Seasons on Meeker
 115 2nd St SE
 Puyallup, Washington

DESIGN: ML/MT
 DRAWN: MT
 CHECKED: ML
 DATE: November 18, 2025
 PROJECT: Seasons on Meeker
 NUMBER: LLA0624.25

DRAWING SET:
**DESIGN REVIEW
SUBMITTAL**

OVERALL PLAN

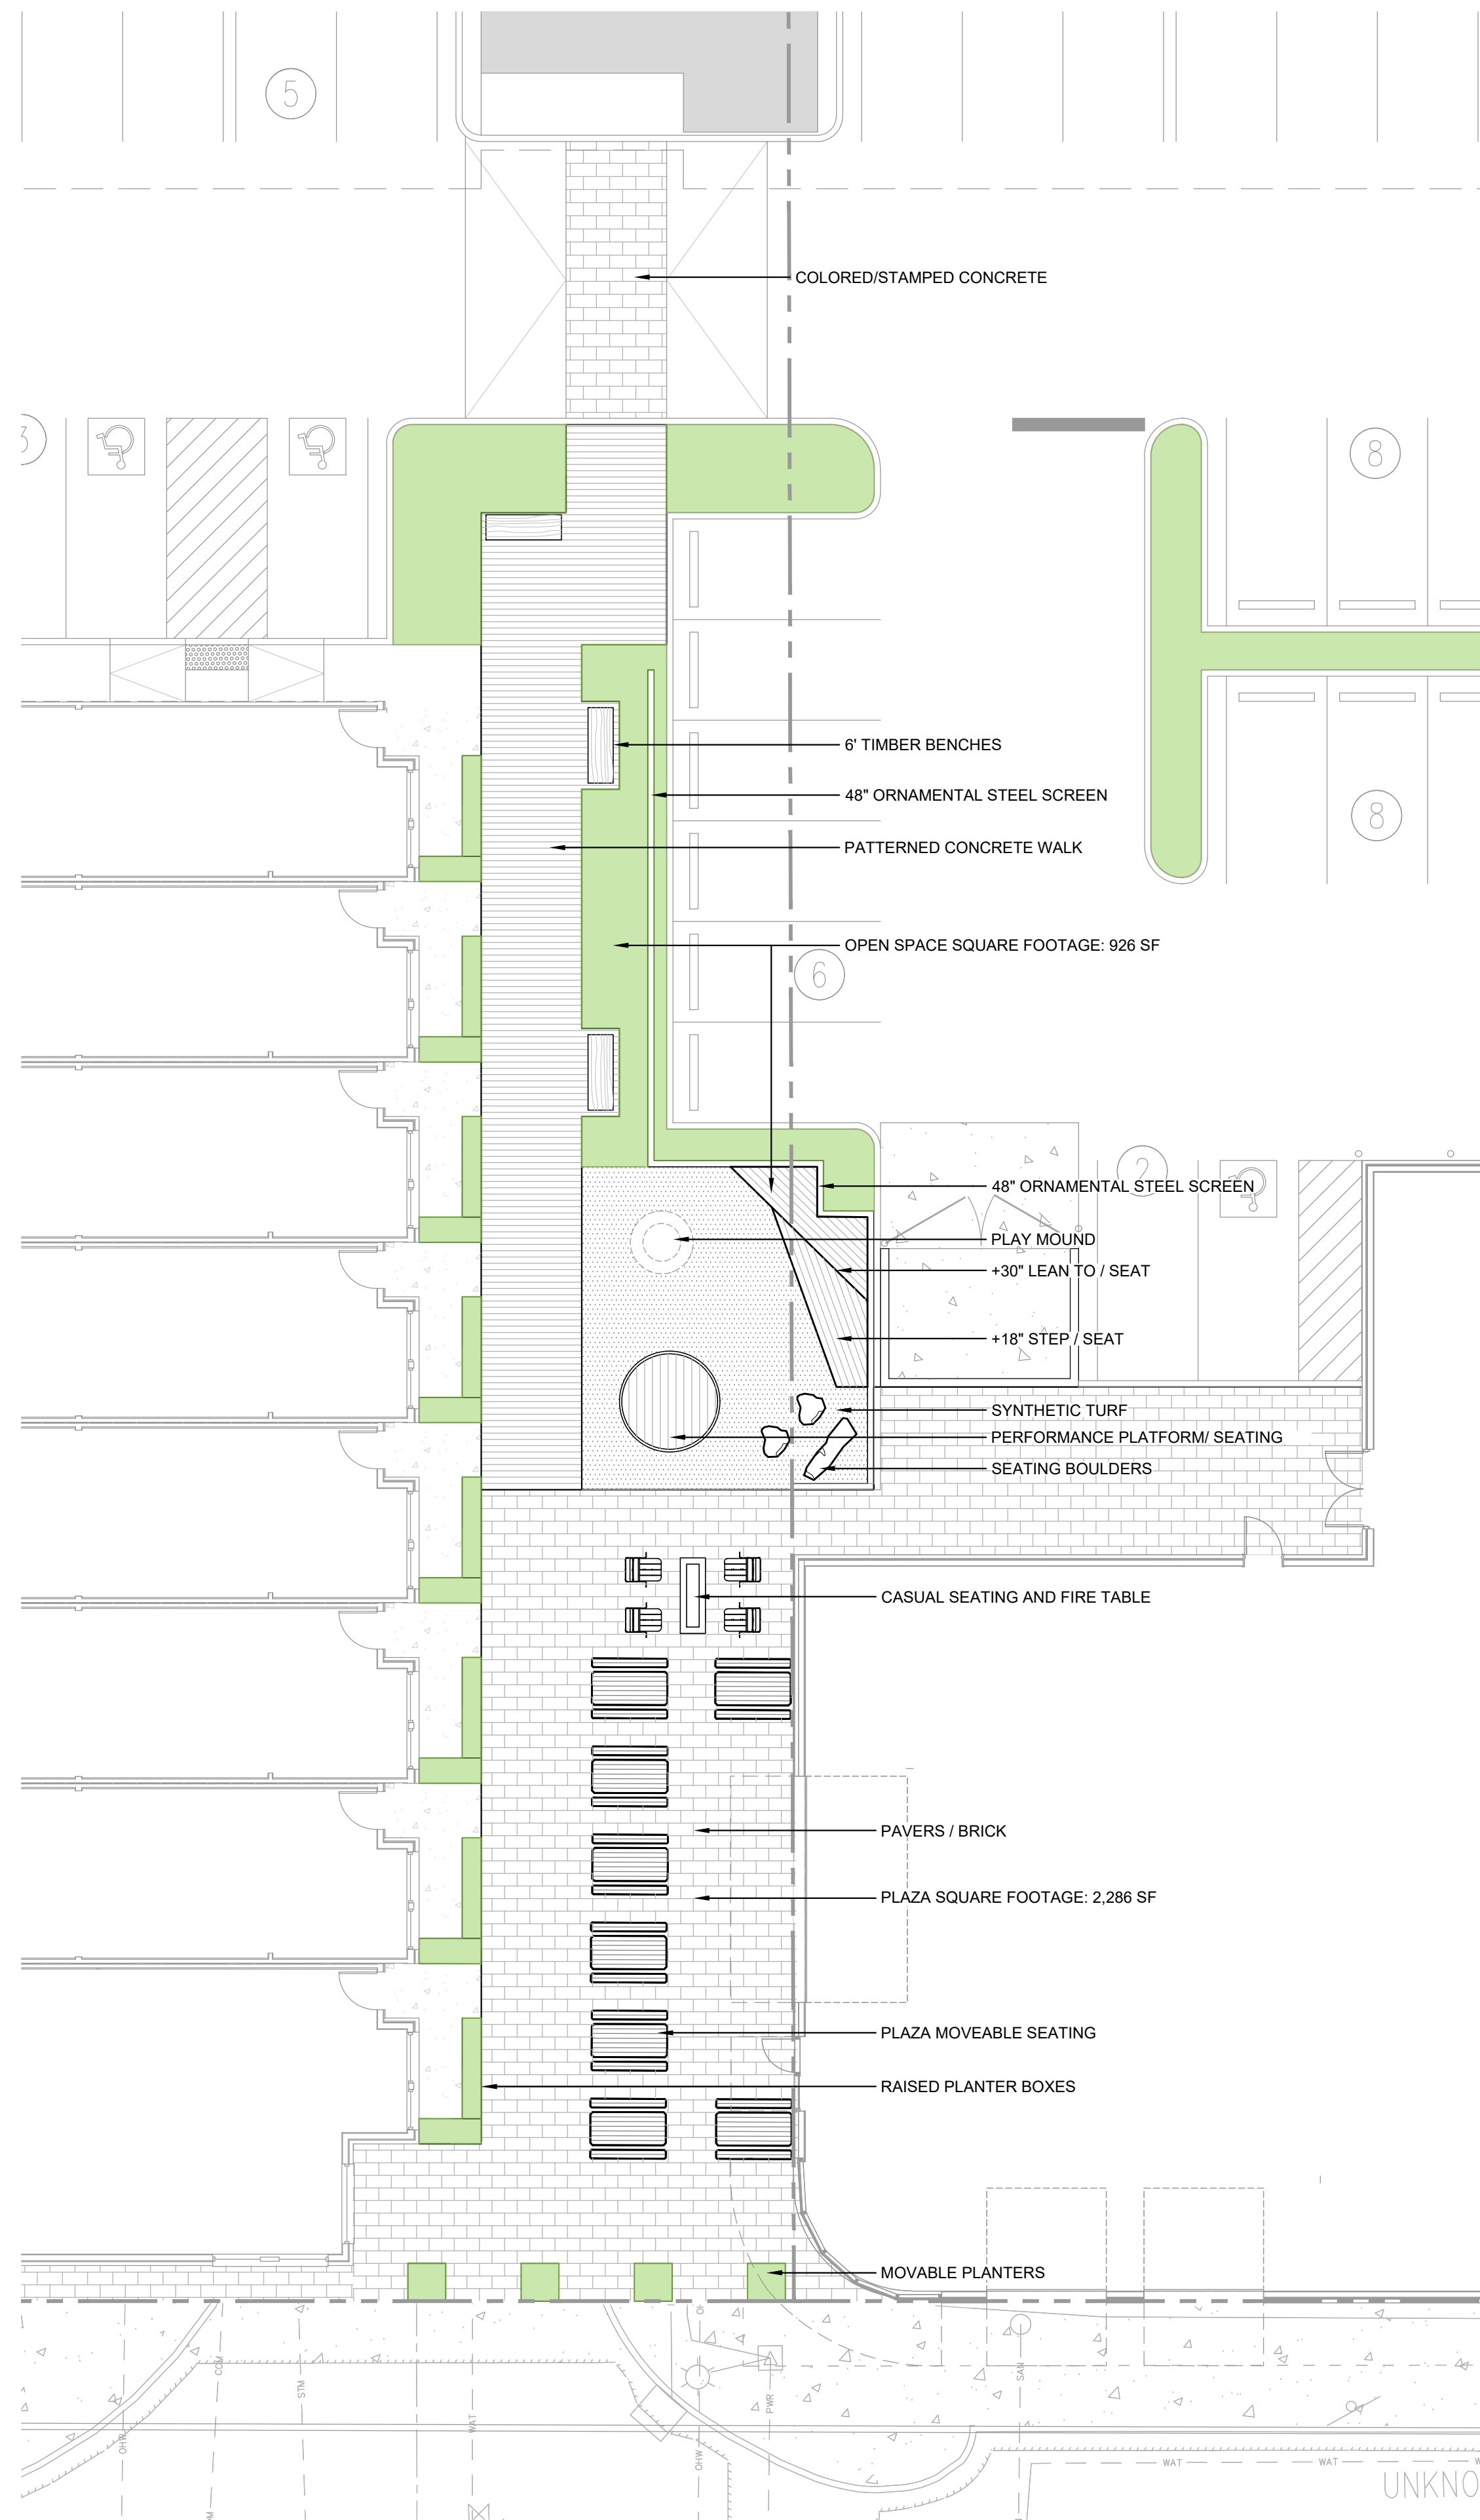
All walkways shall be a minimum of five feet wide with no encroachments. the proposed walkway along the southern elevation of the town homes is about 2.5'. Please demonstrate how the five foot wide walkway is being met. [Landscape Plans, L1.00]

SITE DETAILS

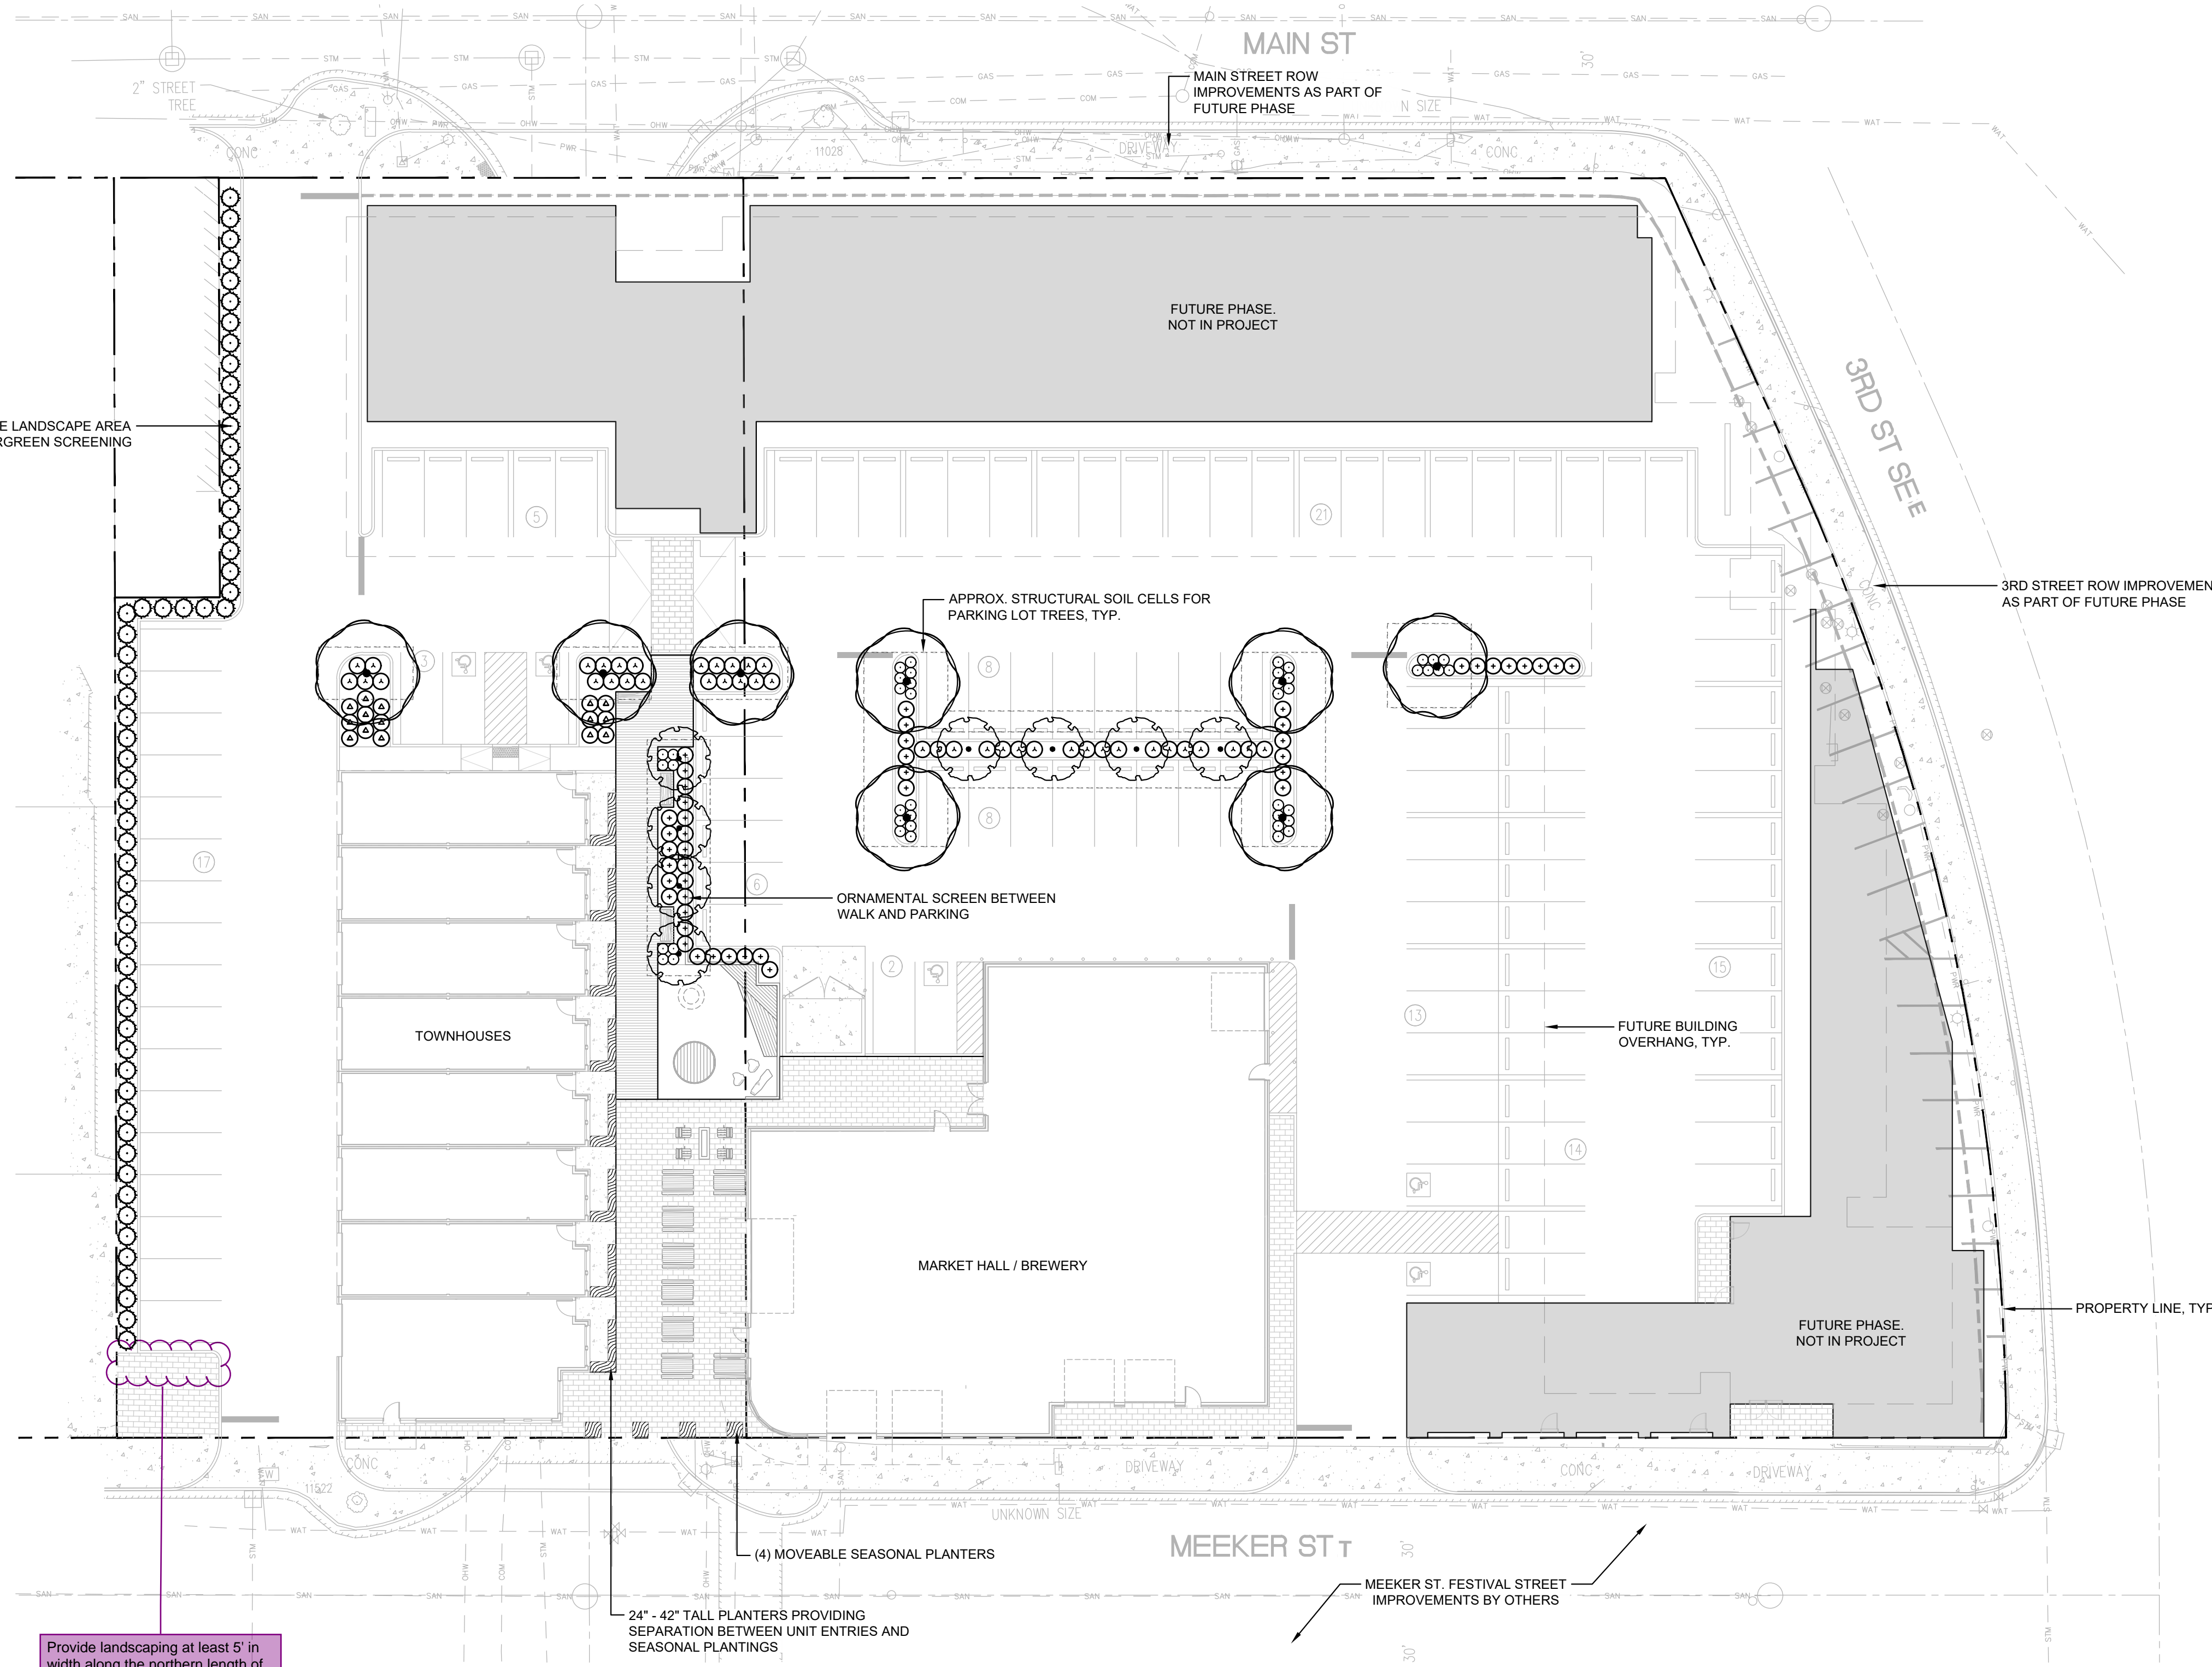
Demonstrate that the required plaza landscaping with 10% of the area being planted trees, shrubs, ground cover, and perennial landscape plantings has been met. Square footage of landscaped area meeting this requirement will suffice. Please note that landscape plantings will be formally reviewed for during the civil permit stage with the final landscape plan set. [Landscape Plans, L3.00]

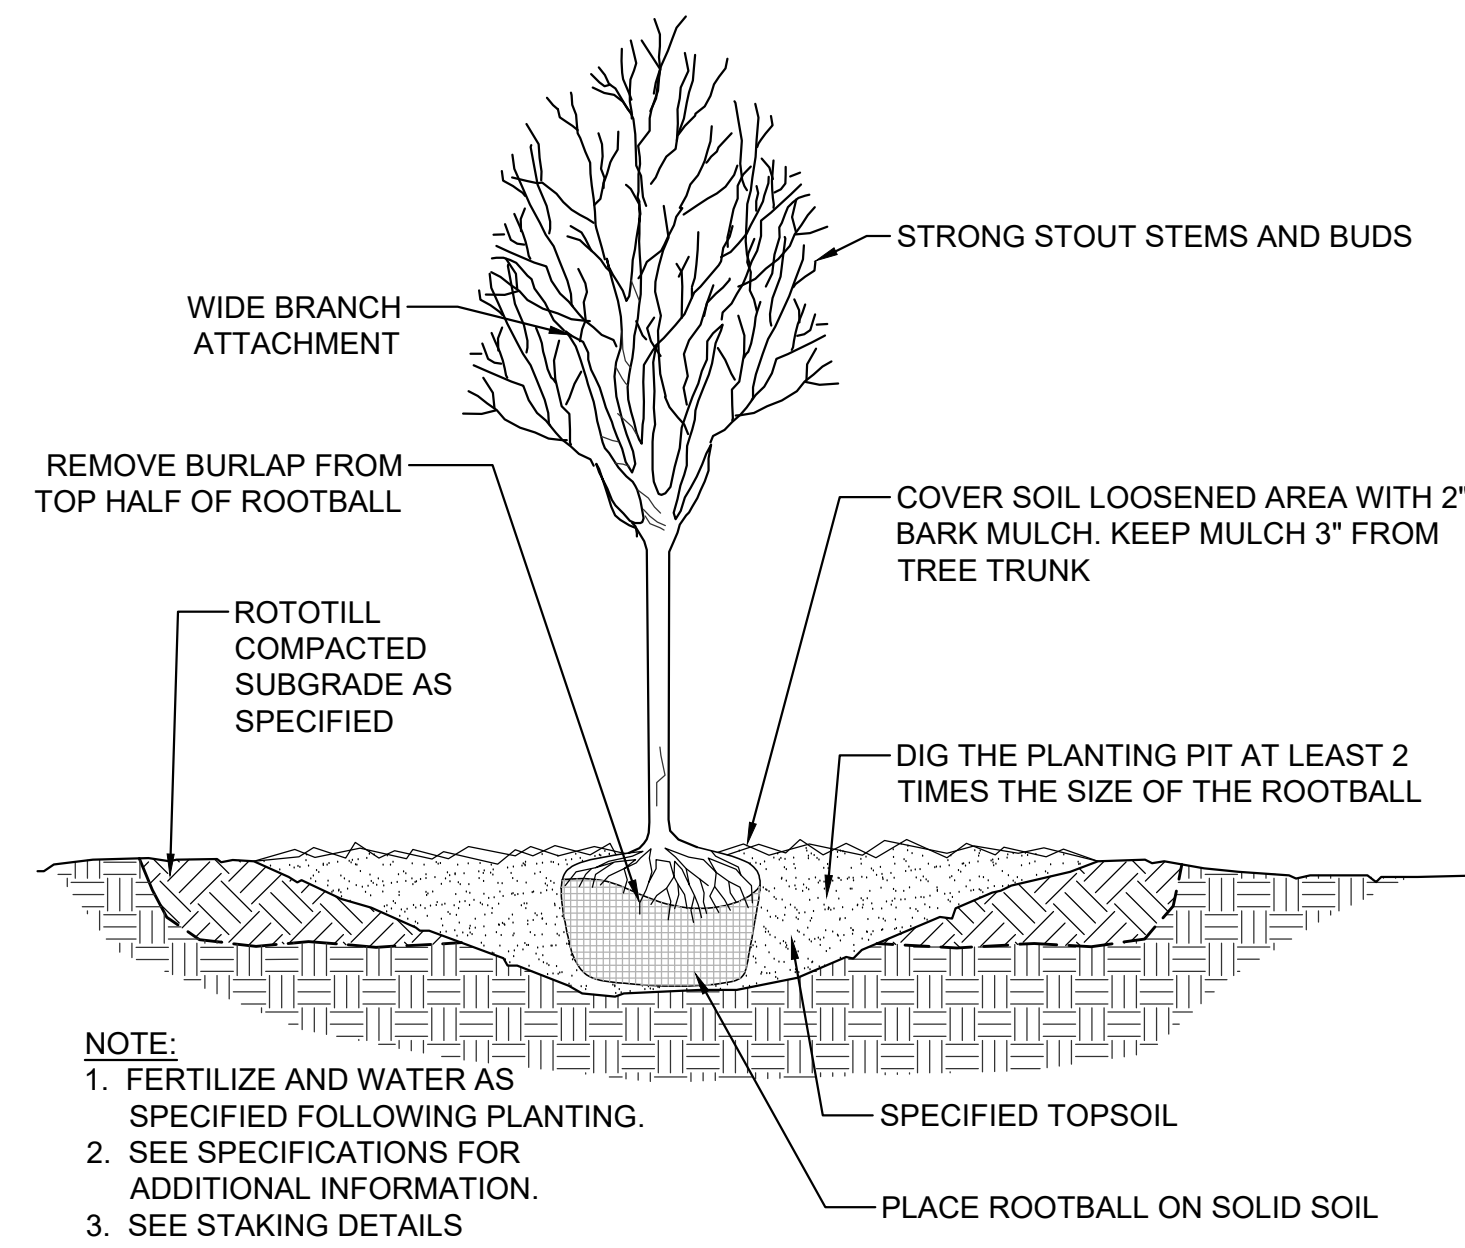
Provide landscaping at least 5' in width along the northern length of this area abutting the most southern parking stall in order to meet required parking screening.

The perimeter of all parking areas and associated access drives which abut public rights-of-way shall be screened with on-site landscaping, earth berms, fencing, or a combination thereof.

Screening shall be located within the required perimeter landscape area and shall include a mix of plants appropriate to achieve 50 percent screening of parked vehicles up to a height of three feet within two years of plant establishment. [Landscape Plans, L3.00]
